Access Compliance Report

Public Rights-of-Way

(Pedestrian Signals)

Intersection ID: N/A	Main Street:	Cross Street: N/A	Location: N/A
ADA ID: A95B50017D10	Signal Type: Two Push Buttons-Non APS	Overall Compliance: No	Severity Score: BTN 1:N/A BTN 2: N/A No BTN: N/A
Codes/Mitigation Info/Possible Solution		Field Measurements/Component Compliance

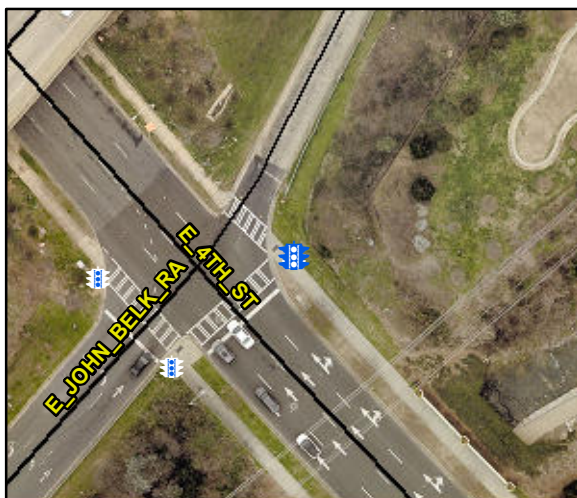
Surveyor Notes: B1 OUT OF SERVICE

Yes	B 1 Clear Xing Direction?	ClearlyMarked	Yes	B 2 Clear Xing Direction?	ClearlyMarked
	B 1 Crossing Direction	To NW		B 2 Crossing Direction	To SW
Yes	B 1 DistanceTo XWalk (in)	53.0	Yes	B 2 DistanceTo XWalk (in)	0.0
No	B 1 DistanceTo Curb (in)	160.0	No	B 2 DistanceTo Curb (in)	153.0
Yes	B 1 Diameter (in)	2.0	Yes	B 2 Diameter (in)	2.0

Possible Solutions: Replace Signal Push Button With APS Button on New Post. Remove & Relocate Sign.
